REDEVELOPMENT OF HARBOURSIDE SHOPPING CENTRE

SSD16_7874

Public Submission

Very large floor plates at
RL41.9, RL54.5, RL 74.5

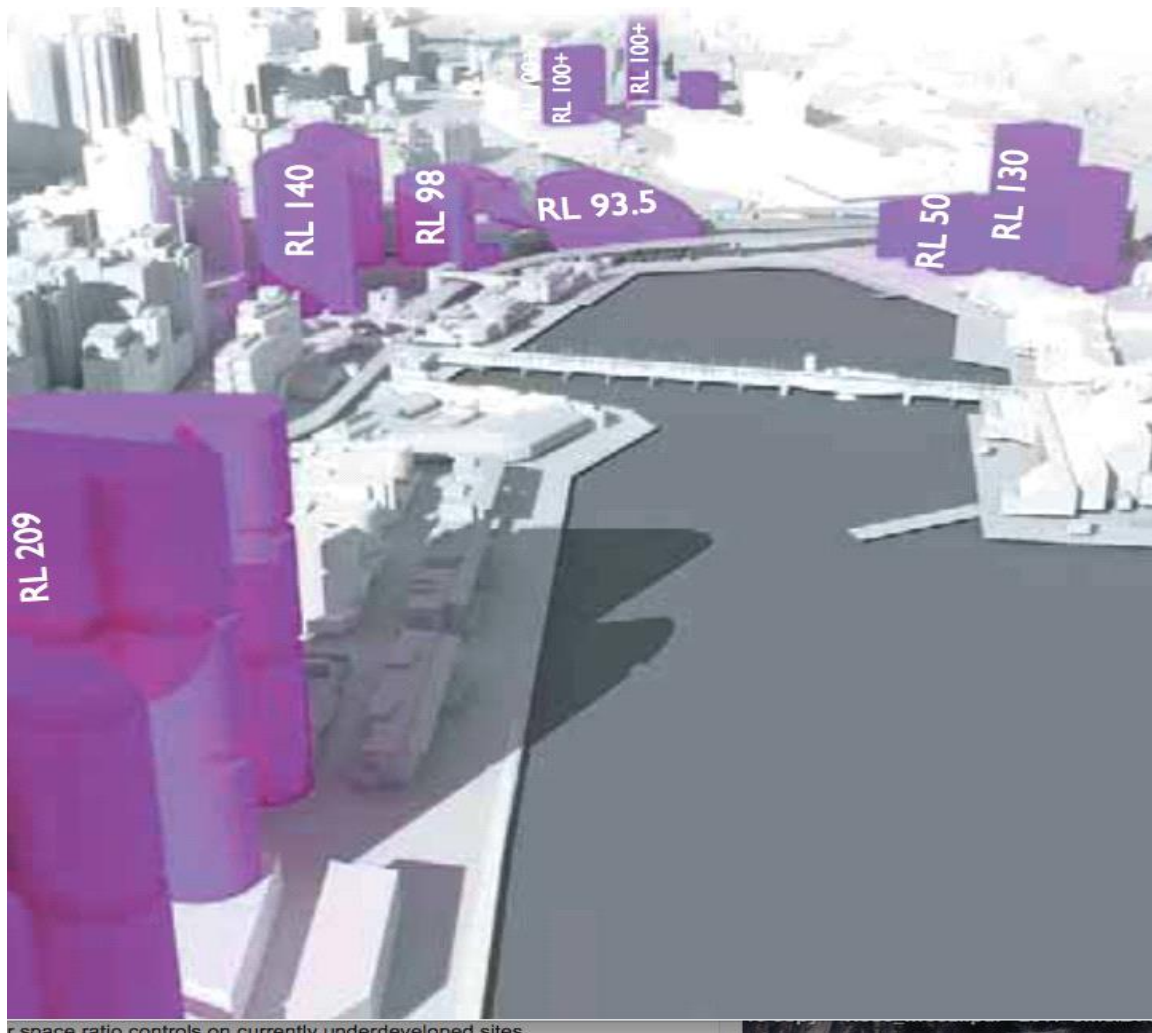
The proposal's is for a non-residential platform of varying RLs from 30.5 to 17.5. On top of this platform it is proposed to put several floor plates of residential at RL41.9, RL 54.5 and 74.5, before a further tower element to RL 166. In fact the proponent has a tower on a very large platform which a tower sits on; the tower is set back at RL30.5, again set back at RL41.9, again set back at RL54.5 and again set back at RL 74.5. To put this in context, the height at which the tower is set back at RL74.5 is well over the height of One Darling Harbour.

The bulk and scale of the tower in particular contrasts with the lower scale character of the Darling Harbour precinct and therefore is visually quite dominant and compromises and unsympathetic to the established valley floor character. The massive floor plates are totally unacceptable. The proponent states the floor plates are some 1,000sqm but this is at the top of the tower. They are massive floor plates lower down as the setbacks take effect. This is a residential development and not a commercial as before where floor plates of up to 1,200sqm are acceptable. The Department often quotes that residential towers should not exceed a floor plate of 600-800GBA and this should certainly be the limit in this sensitive area of Sydney.

I consider for these reasons The 'wings' of the tower element are not acceptable and should not be supported and the Tower floor plate above the shopping centre platform not exceed 800GBA with a maximum width of 25 meters.

Proponent's Central Tower Option more sympathetic to the heritage Pyrmont Bridge

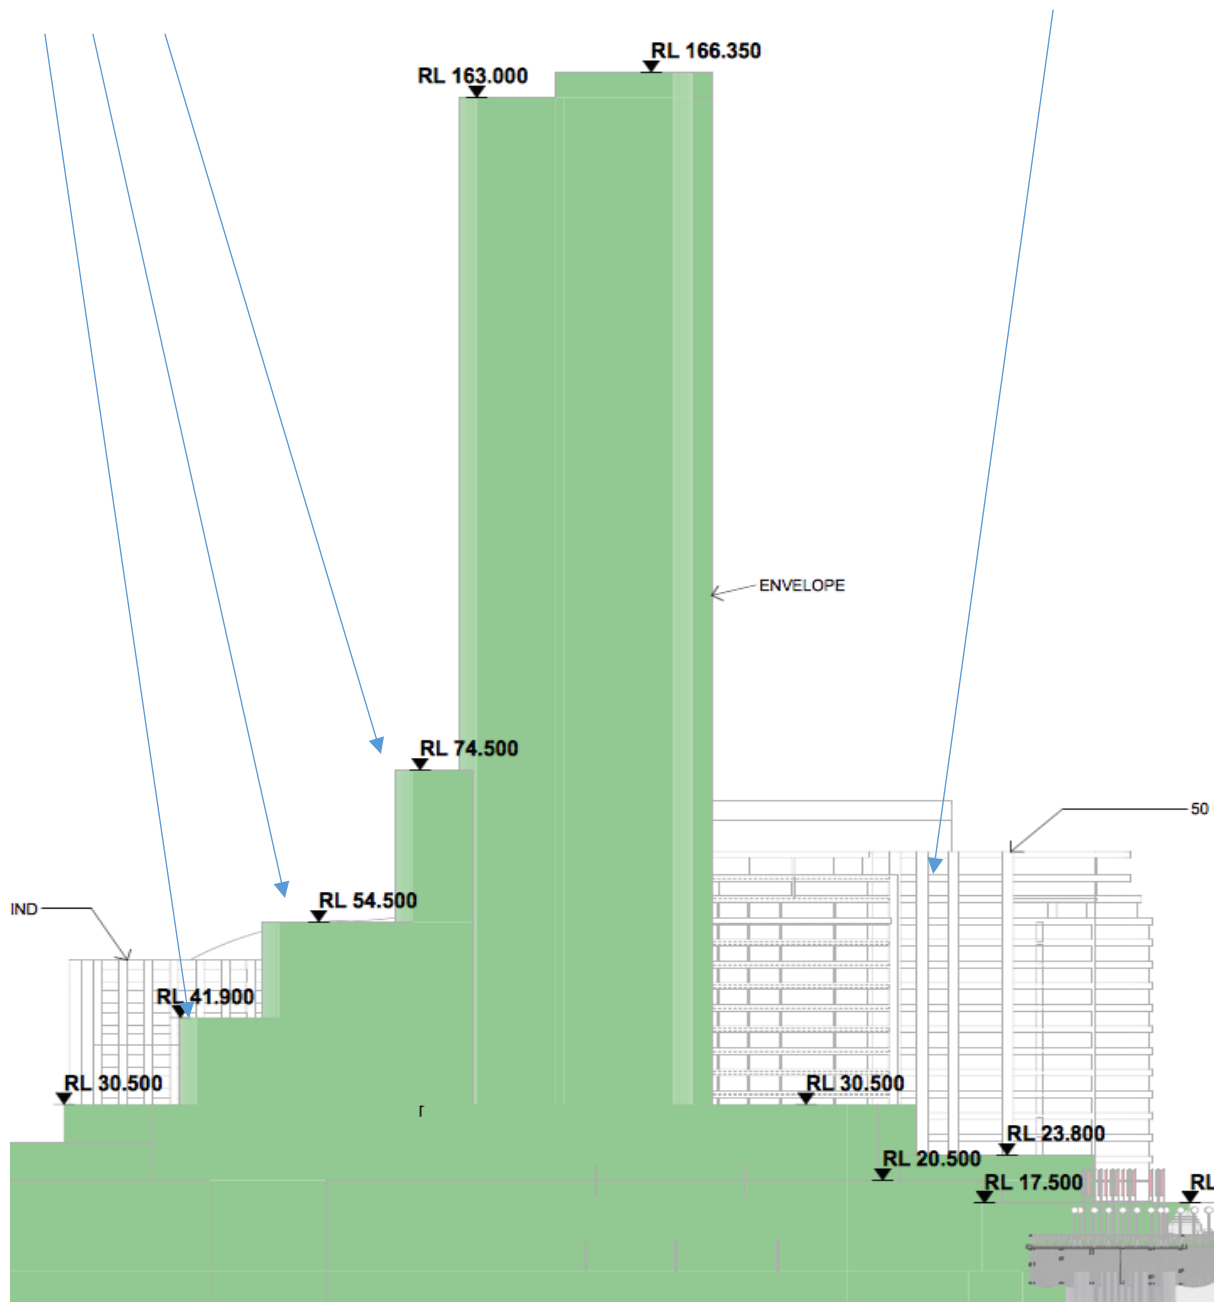
Further, the massing across the site to the north is inconsistent with the proximity of the Heritage listed Pyrmont Bridge. The IMAX (RL50) defines the termination to the south of Cockle Bay and Pyrmont Bridge defines the termination of Cockle Bay to the north and the massing of the proposal towards the Bridge is inappropriate,

unsympathetic and overpowering – this is addressed further below. It is noted that the tower element of the proposal has been moved north tens of meters from the original ‘commercial building proposal’ but the mass has increased and is now residential rather than commercial. Moving it a tens of meters may make a few objectors less unhappy but it does not address the fundamental planning principles as they relate to significant listed heritage items. Unlike the IMAX site, this site has significant flexibility to deal with many of the issues and it has failed to do so. The ‘Central Tower’ option (moving the tower element in the gap between Novotel and IBIS)– see later for details - as outlined by the proponent would provide a much more sympathetic approach in dealing with the proximity to the Bridge.

I consider that the massing towards the Bridge is not acceptable and that it is far more acceptable under the “central Tower” option. Further the RL to the north of the site fronting Pyrmont Bridge should not exceed RL 17.5 for 50m and not exceed RL25.5 for a further 50meters ie 100m from the bridge.

Massing towards
Pyrmont Bridge

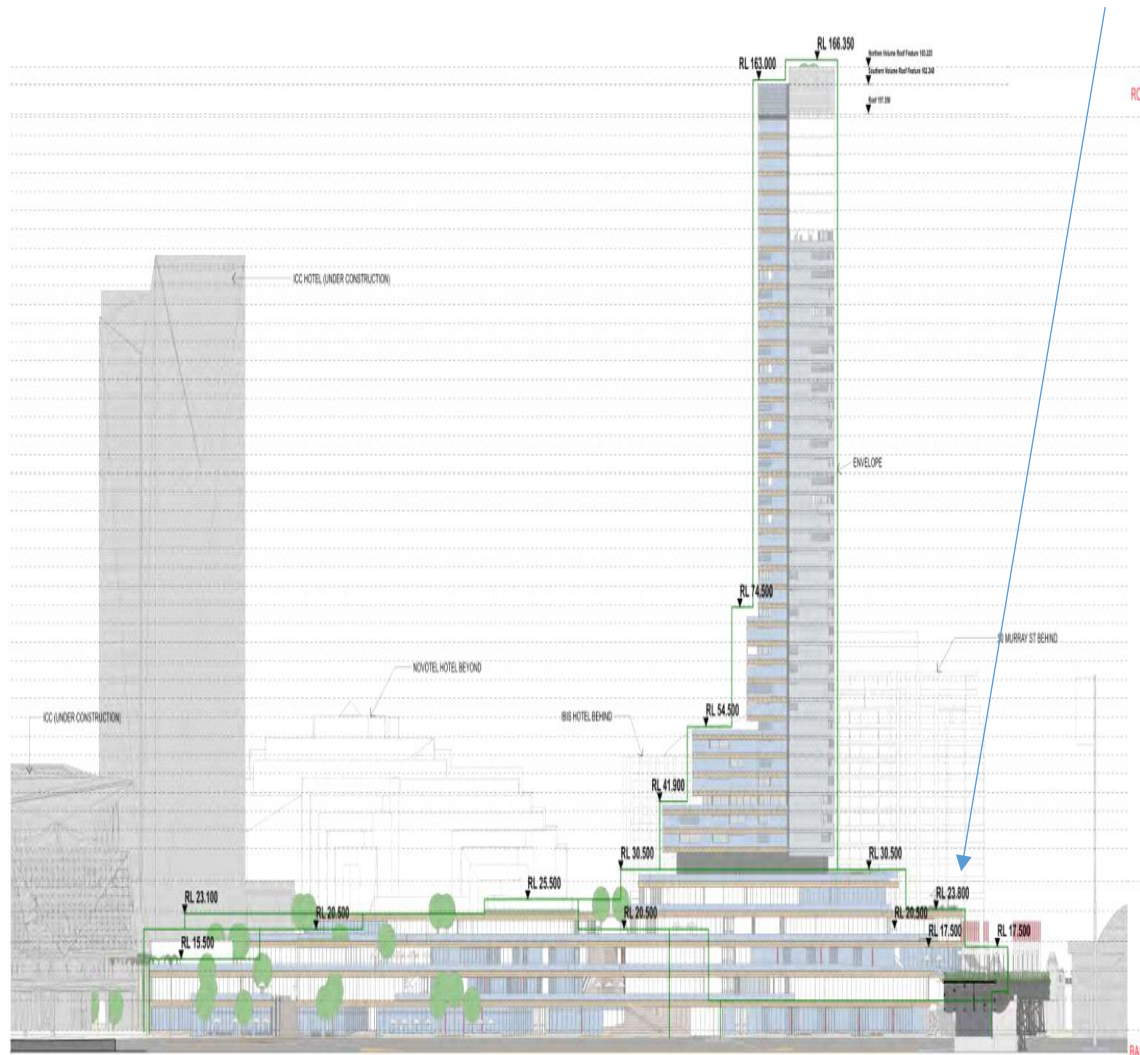
The height of southern section of the proposal is at RL 25. At the northern edge the RL climbs to RL 166 and declines with platforms at RL30.5 and RL23.8 some 10 meters from the heritage bridge.

The proposed massing across the site to the north is inconsistent with the proximity of the Heritage listed Pymont Bridge. The IMAX (RL50) defines the termination to the south of Cockle Bay and Pymont Bridge defines the termination of Cockle Bay to the north and the massing of the proposal towards the Bridge is inappropriate,

The Central Tower Option

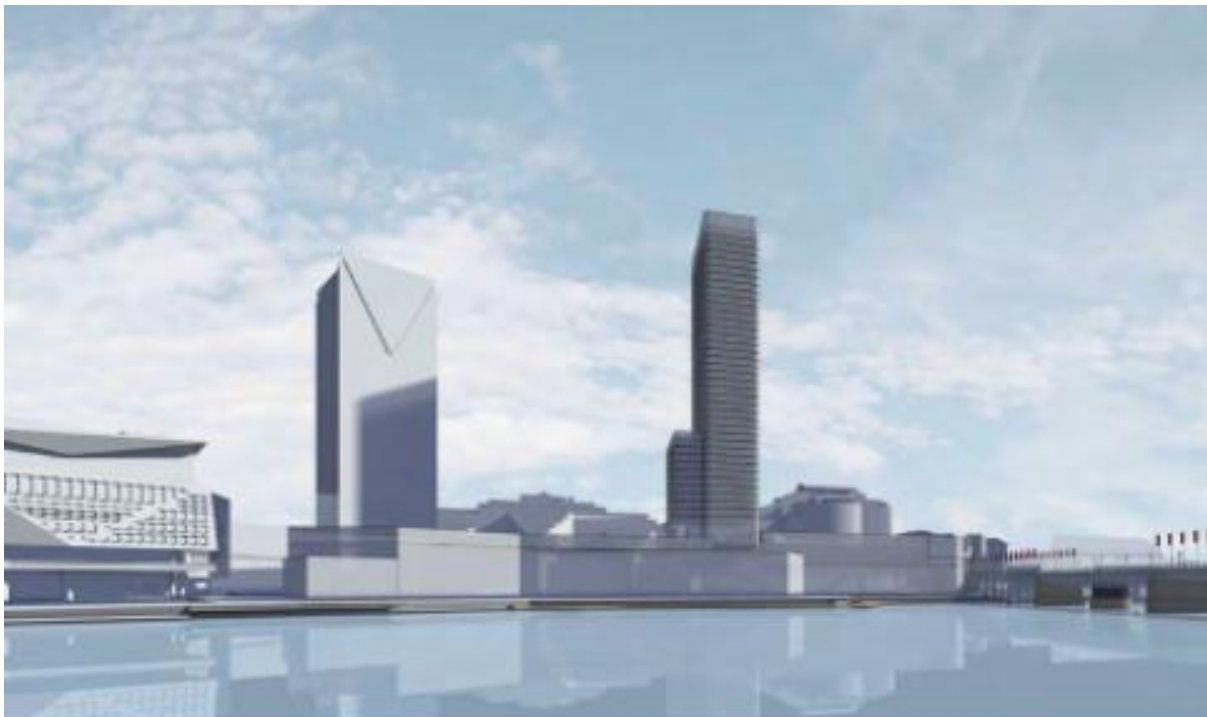
There is a significant gap between IBIS and Novotel hotels which aligns with east – west Bunn Street across from Murray Street. Placing the tower at this location which the proponent has identified as Central Tower addresses many of the environmental issues without reducing the development potential and amenity. This location allows view corridors for the Novotel Hotel, IBIS Hotel and One Darling Harbour. Second, it moves it further away from the heritage Pyrmont Bridge. By reducing the height it will

have no further impact on the public domain than the proposed option. It is a significant distance away from the IIC Hotel to cause privacy concerns.
